WASHINGTON PUBLIC POWER SUPPLY SYSTEM

AMENDMENT TO FACILITY OPERATING LICENSE

Amendment No. 145  
License No. NPF-21

AMENDMENT NO. 145 TO FACILITY OPERATING LICENSE NO. NPF-21

CORE FLOW (% RATED)  
Operating Region Limits of Specification 3.2.7  
Figure 3.2.7-1

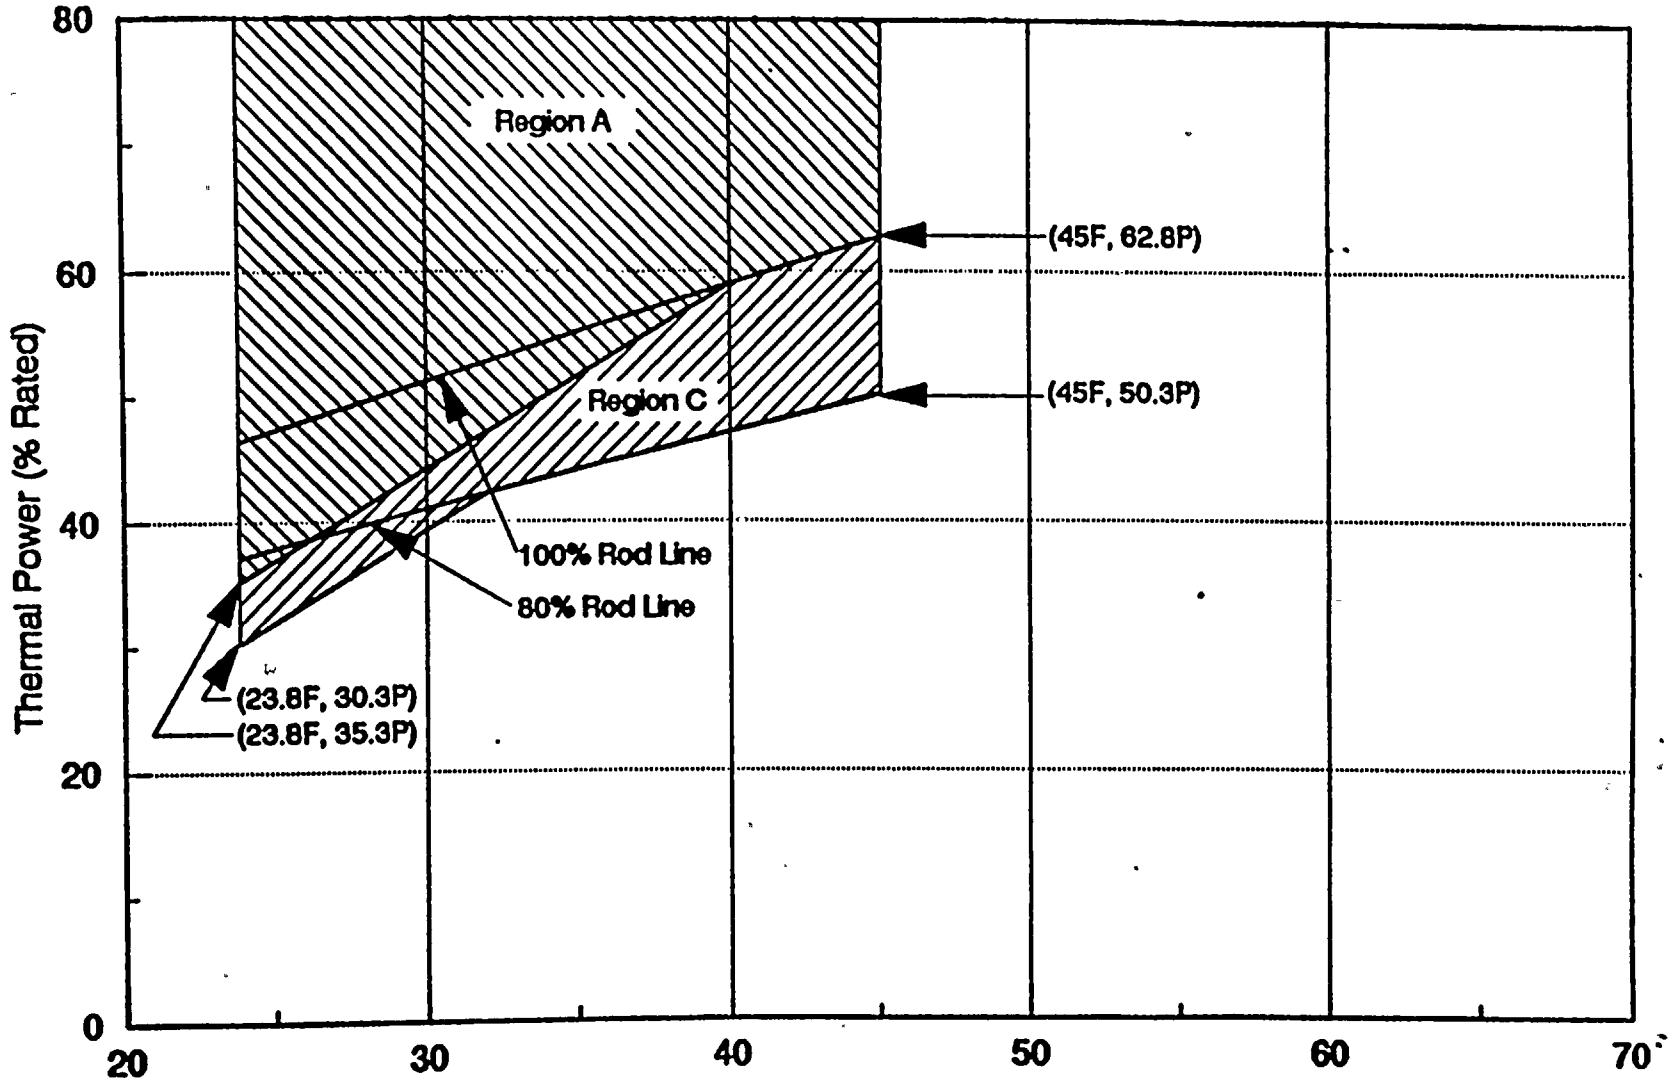
3.2.7 The stability monitoring system shall be operable\* and the decay ratio of the neutron signals shall be less than .75 when operating in the region of APPLICABILITY.

**APPLICABILITY:** OPERATIONAL CONDITION 1, with two recirculation loops in operation and THERMAL POWER/core flow conditions which lay in Region C of Figure 3.2.7-1.

Core Flow (% RATED)  
Operating Region Limits of Specification 3.2.8  
Figure 3.2.8-1

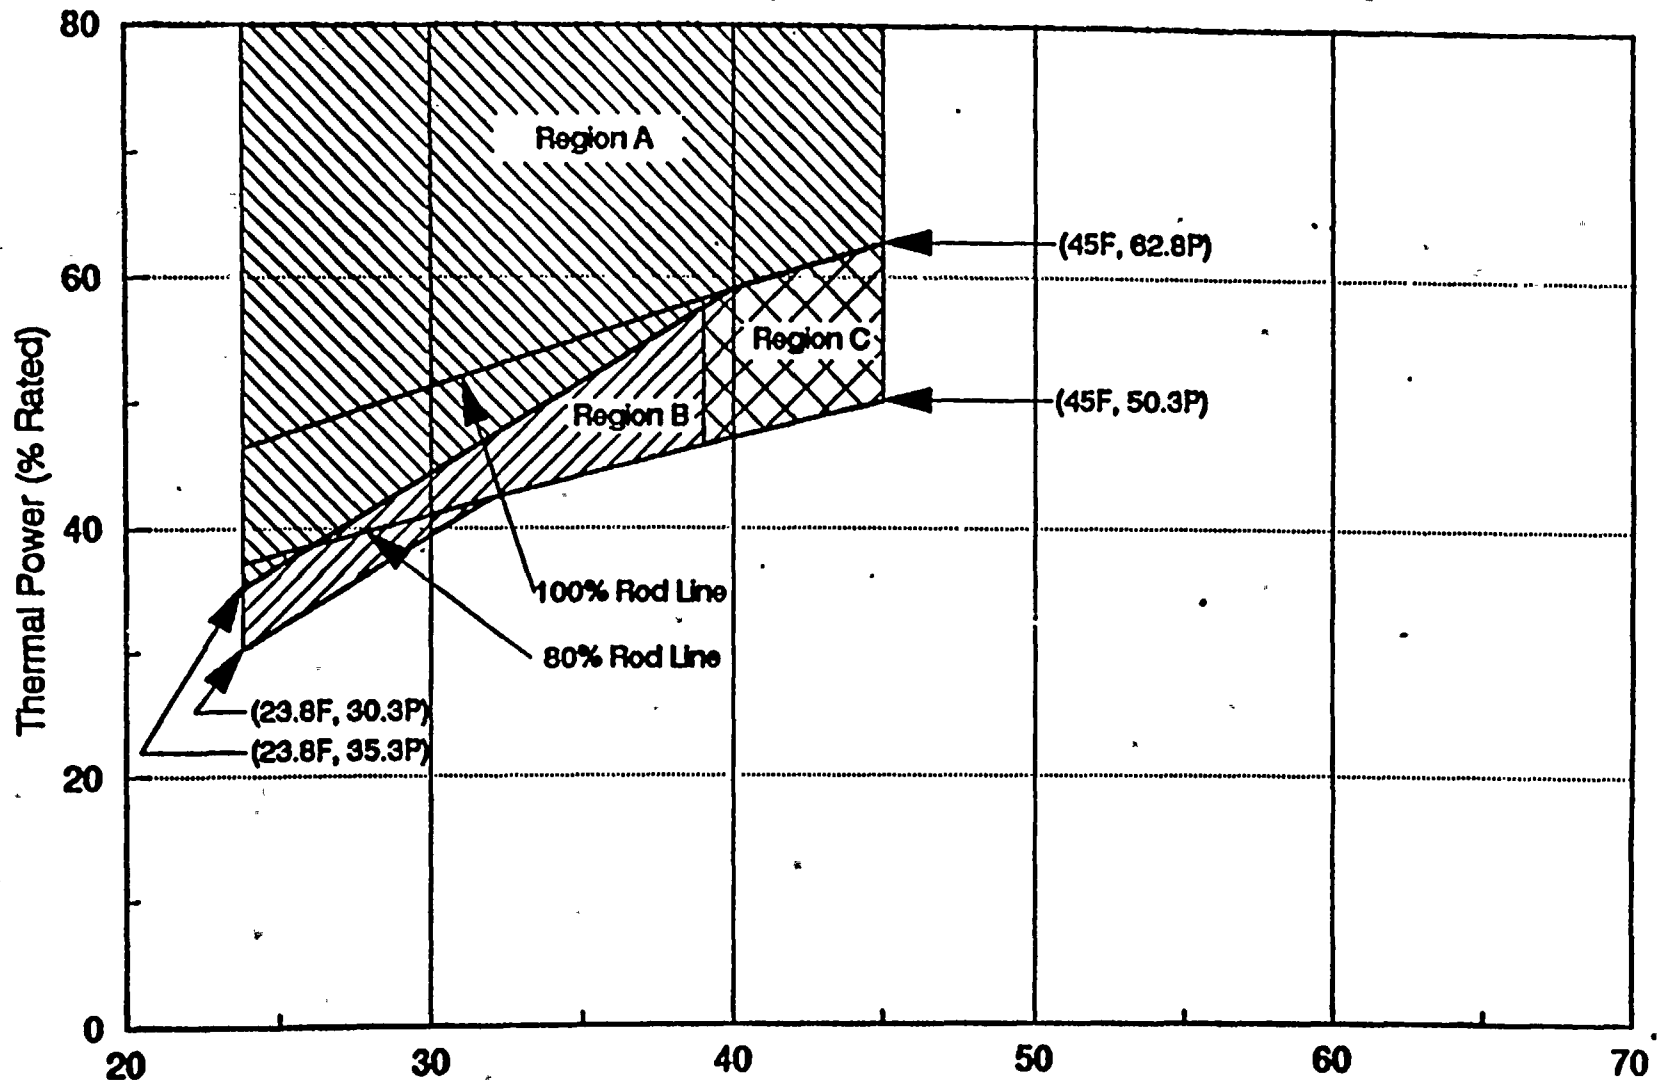
3.2.8 The stability monitoring system shall be operable\* and the decay ratio of the neutron signals shall be less than .75 when operating in the region of APPLICABILITY.

APPLICABILITY: OPERATIONAL CONDITION 1, with one recirculation loop in operation and THERMAL POWER/core flow conditions which lay in Region C of Figure 3.2.8-1.

Core Flow (%Rated)  
OPERATING REGION LIMITS OF SPECIFICATION 3.4.1.1  
FIGURE 3.4.1.1-1

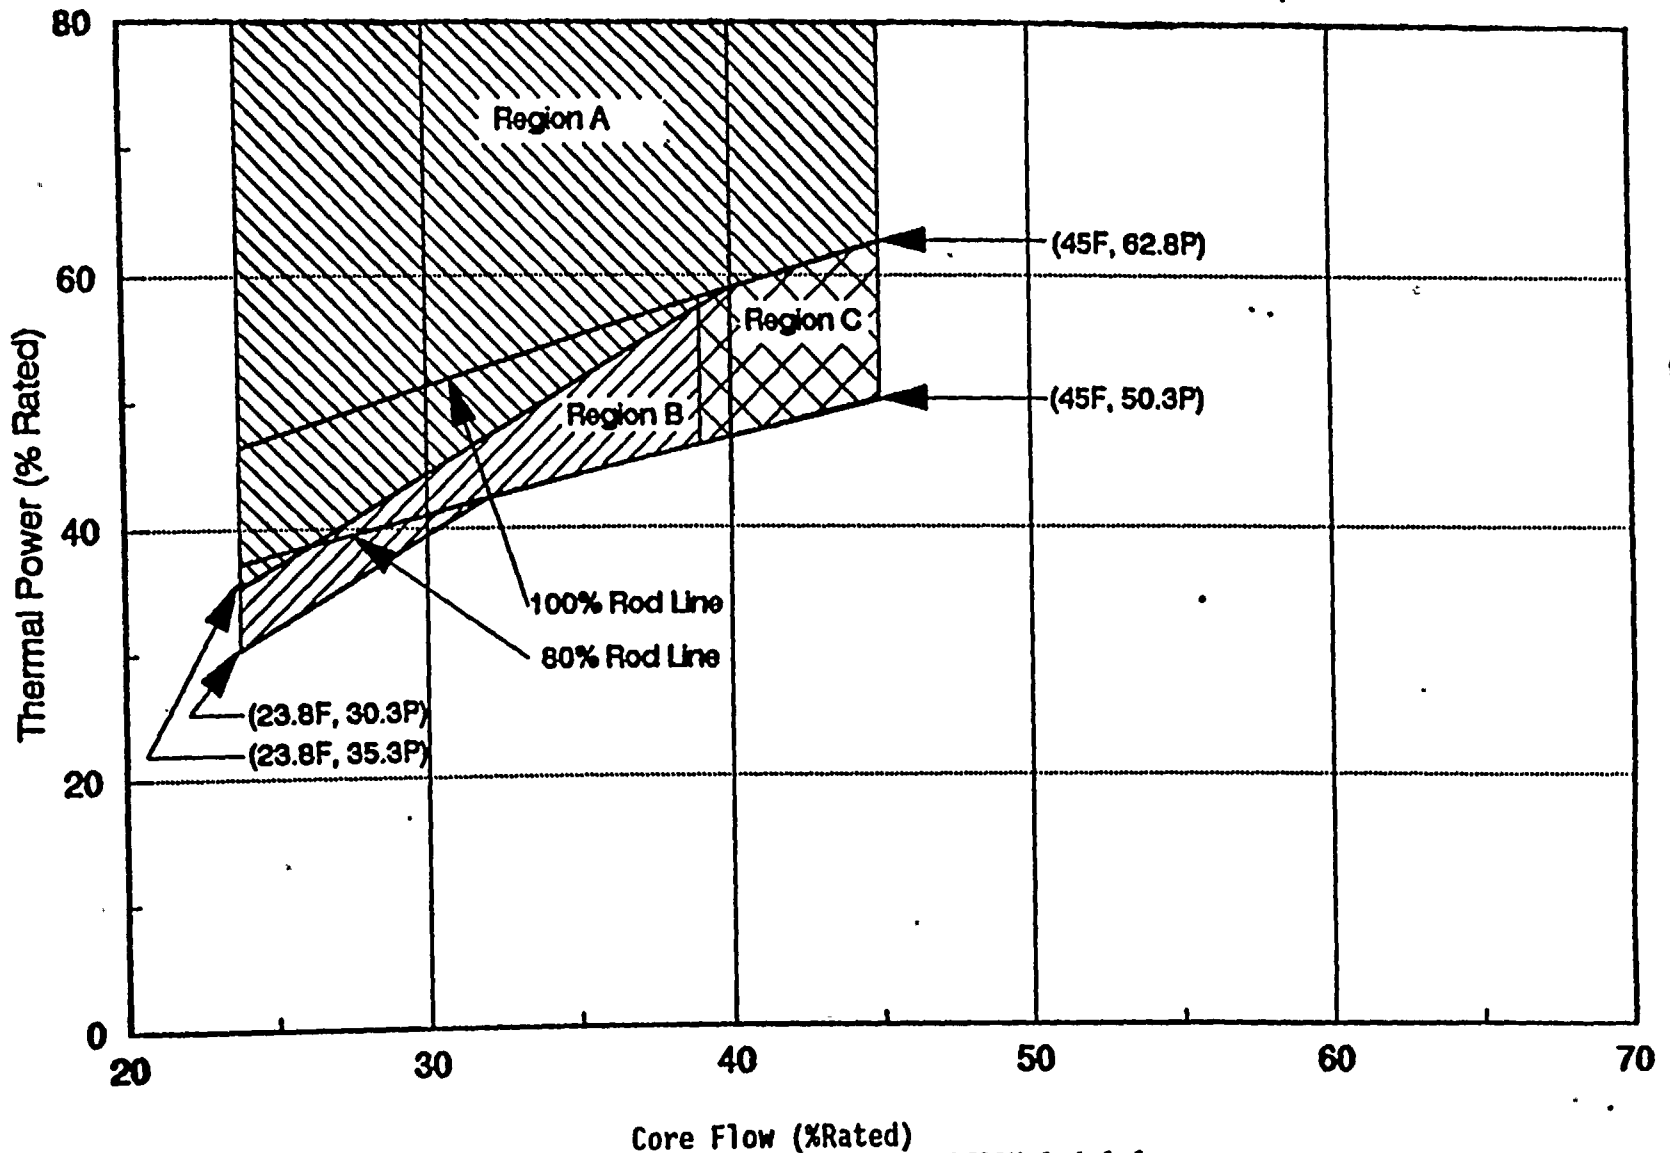
1. Verify that the requirements of LCO 3.2.6 and LCO 3.2.8 are met, or comply with the associated ACTION statements.
2. Verify that THERMAL POWER/core flow conditions lay outside Region B of Figure 3.4.1.1-1.

With THERMAL POWER/core flow conditions which lay in Region B of Figure 3.4.1.1-1, as soon as practical, but in all cases within 15 minutes, initiate action to exit Region B by either decreasing THERMAL POWER with control rod insertion or increasing core flow. Within 1 hour exit Region B. The starting of a recirculation pump for the purpose of exiting Region B is specifically prohibited.
